**PASCAGOULA PUBLIC LIBRARY
REPAIRS AND RENOVATIONS
JACKSON COUNTY BOARD OF SUPERVISORS
PASCAGOULA, MISSISSIPPI**

00.910 ADDENDUM NO 1.

This Addendum forms a part of the Contract Documents and modifies the original Bidding Documents. The following clarifications, changes, additions, or deletions shall be made to the following documents as indicated and all other conditions shall remain the same.

1 DETAIL OF MODULAR AHU-1
M-503 SCALE: 3/4" = 1'-0"

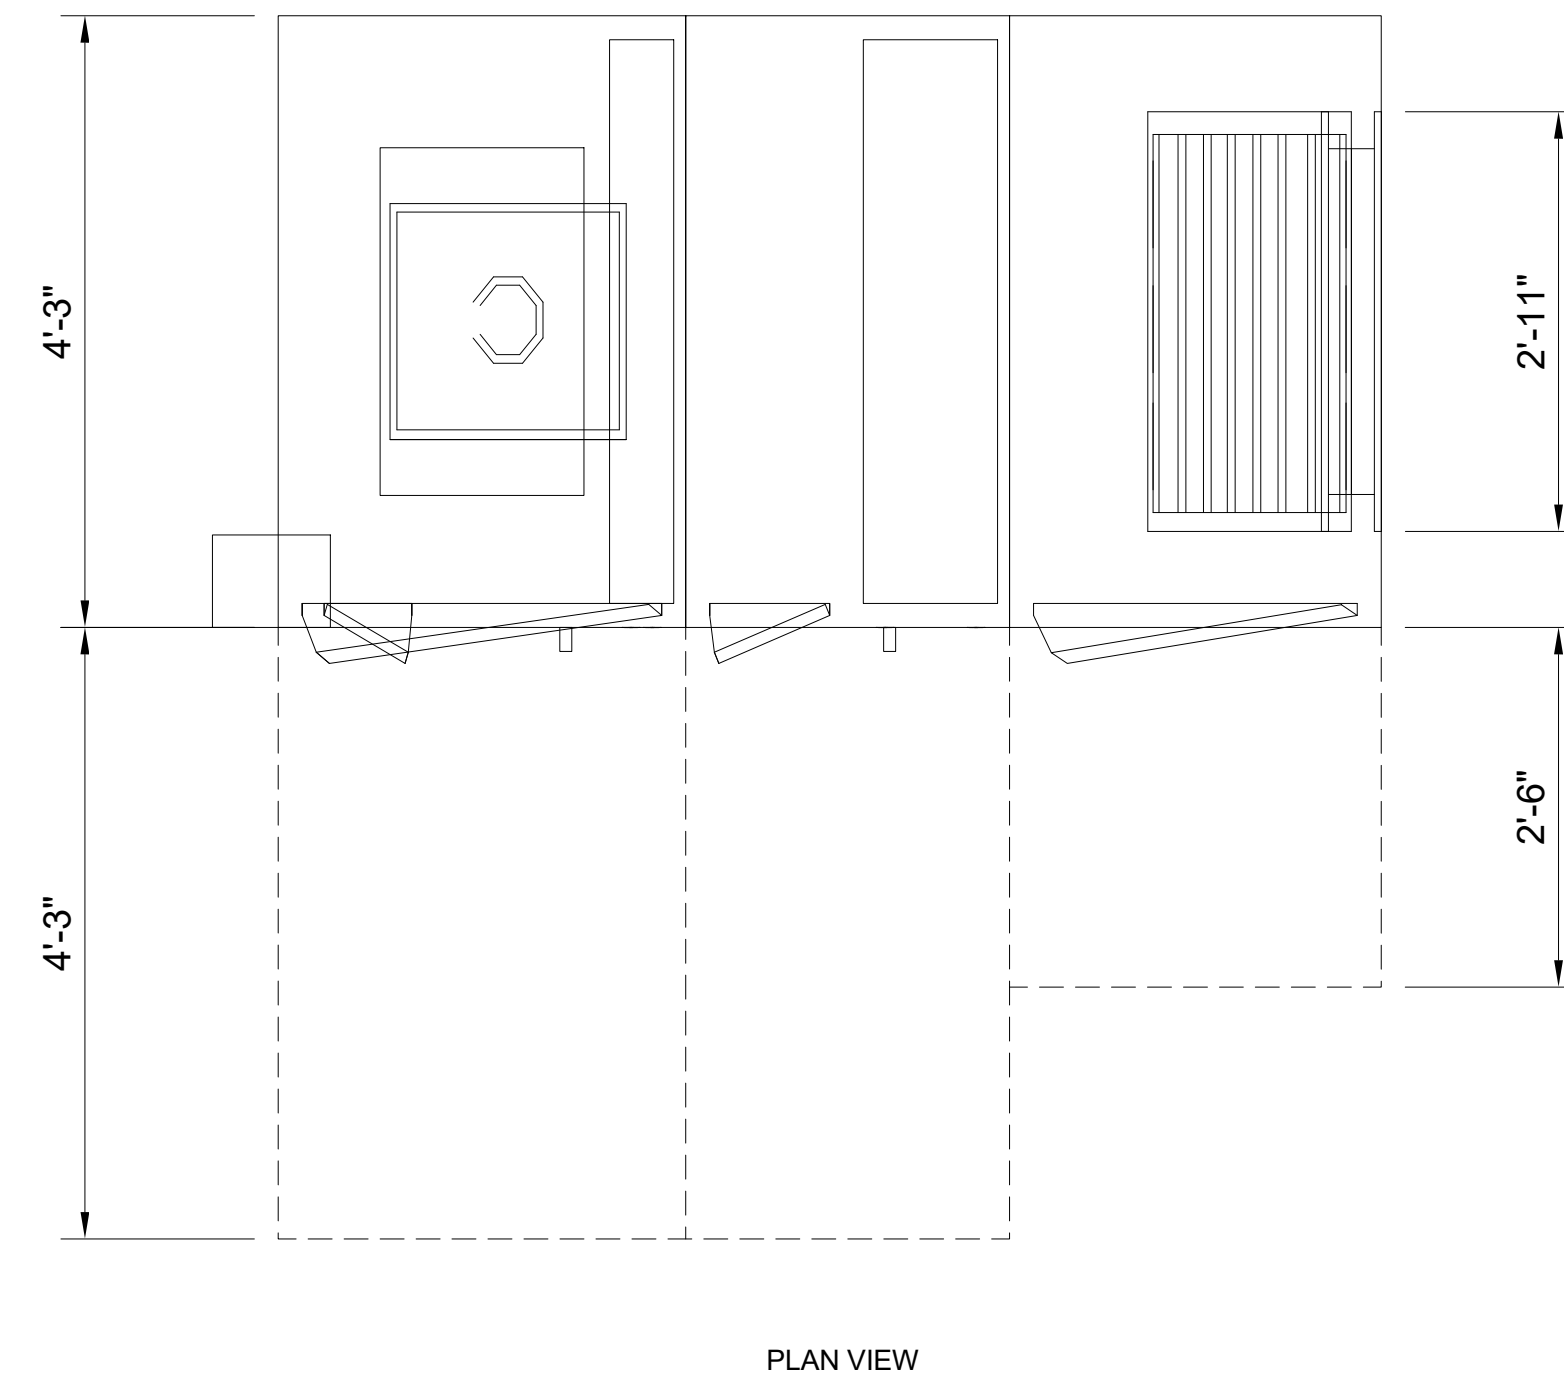
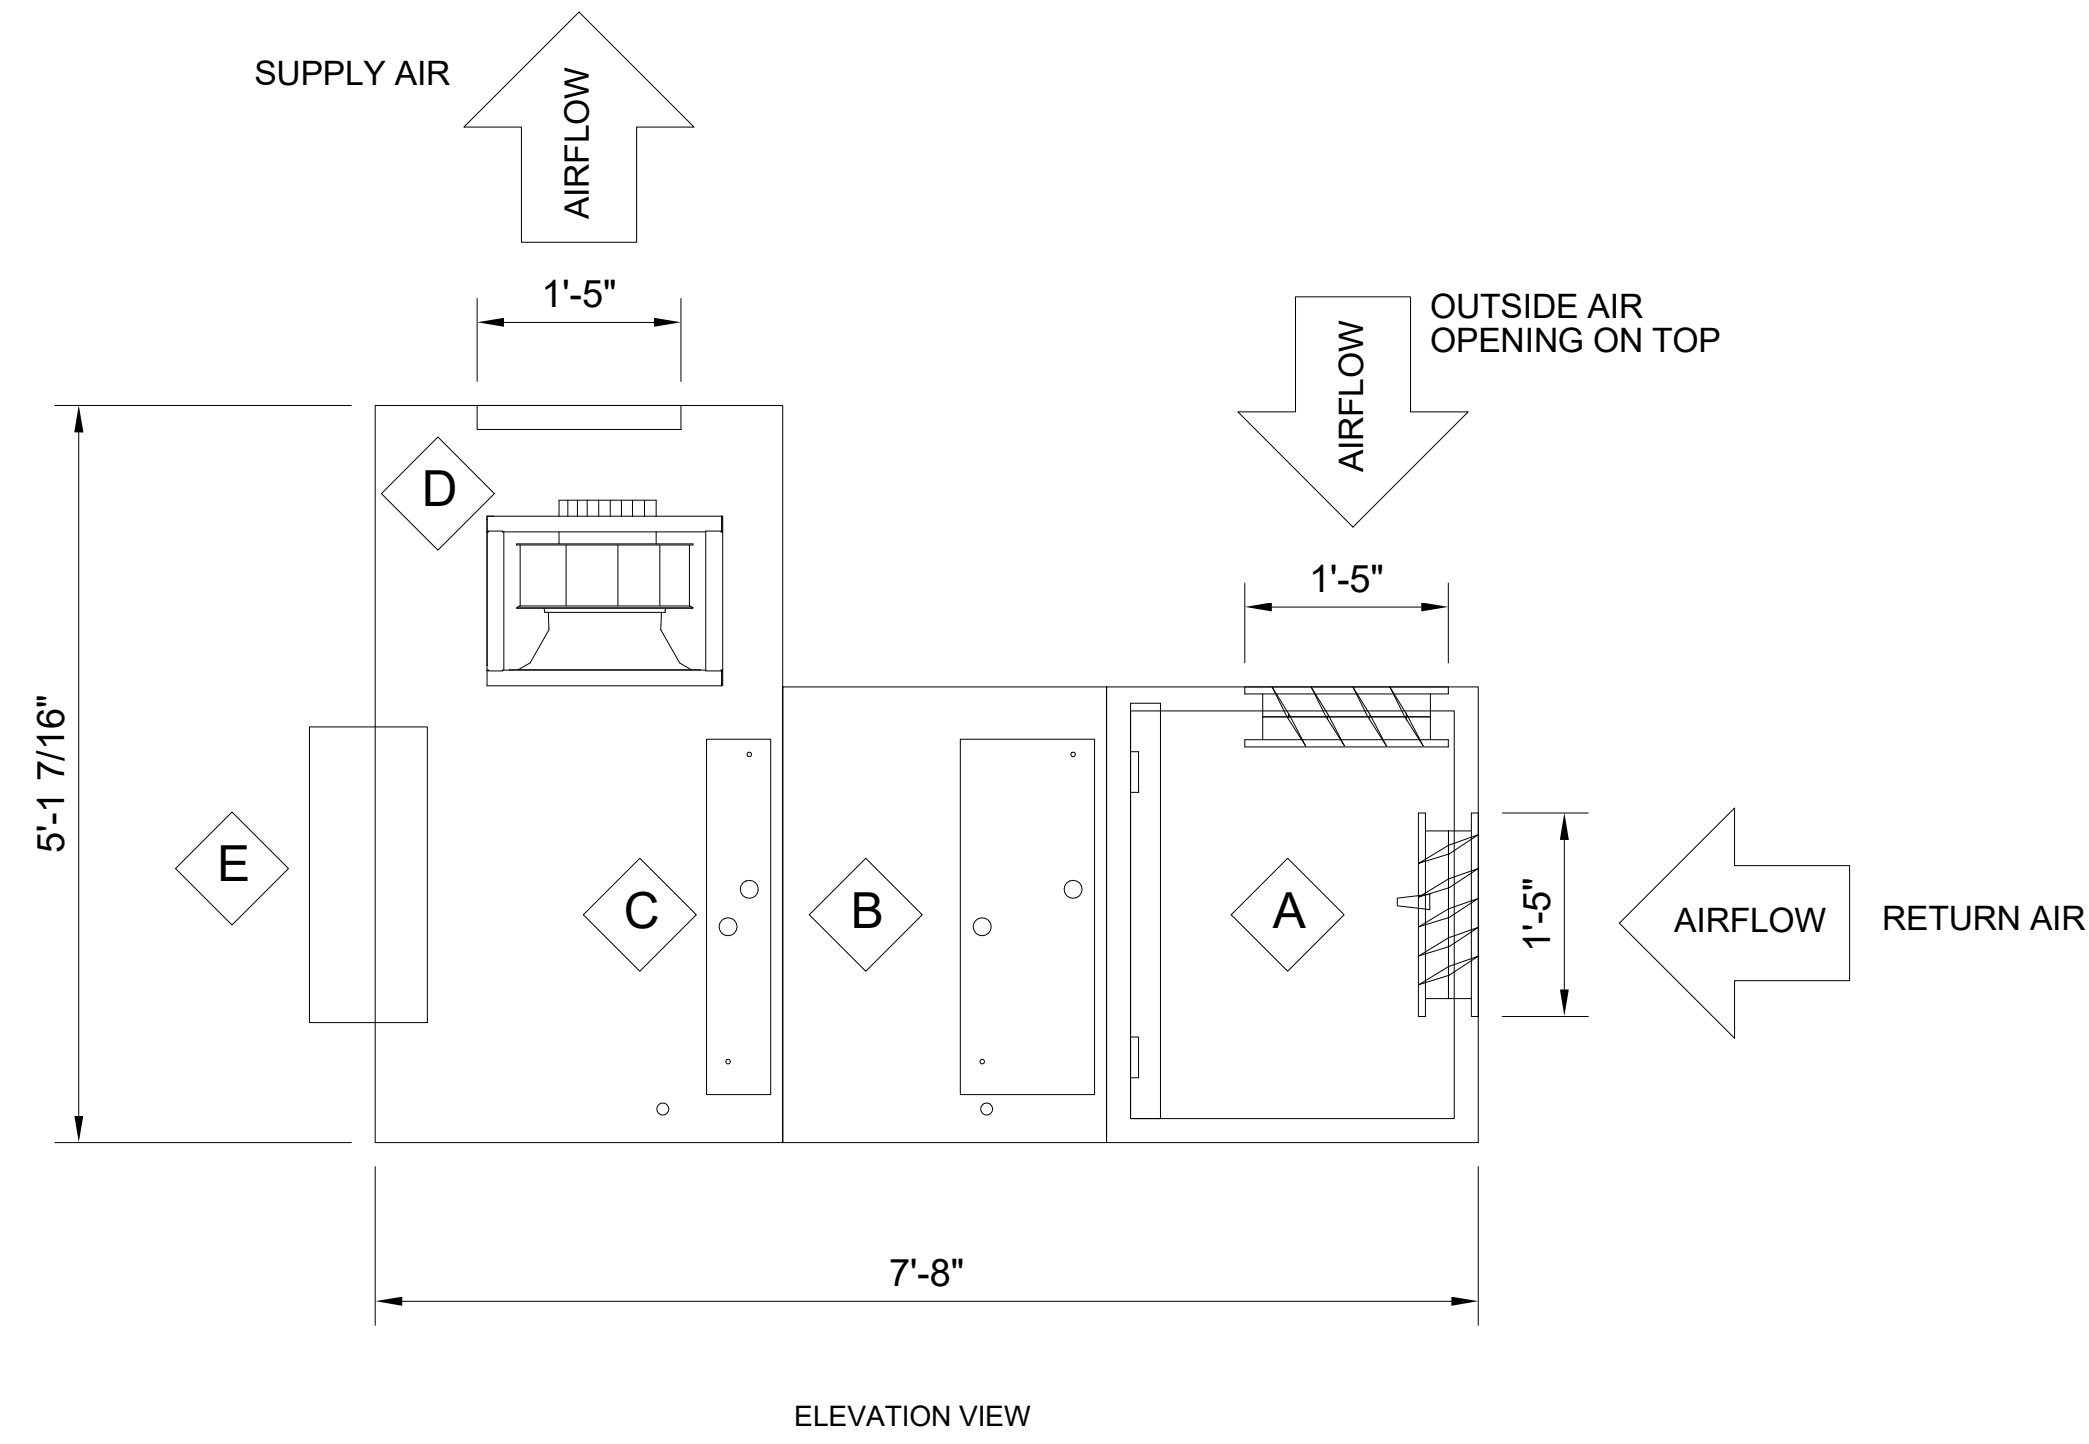
- E. Clarification: AHU-1 has a motorized impeller (EC motor directly connected to fan shaft). Fan control points shall include: Fan Status (CS-1), Fan Start/Stop (Connect to ECM “Run” contact, Fan Speed (Connect to ECM “Speed” contact).
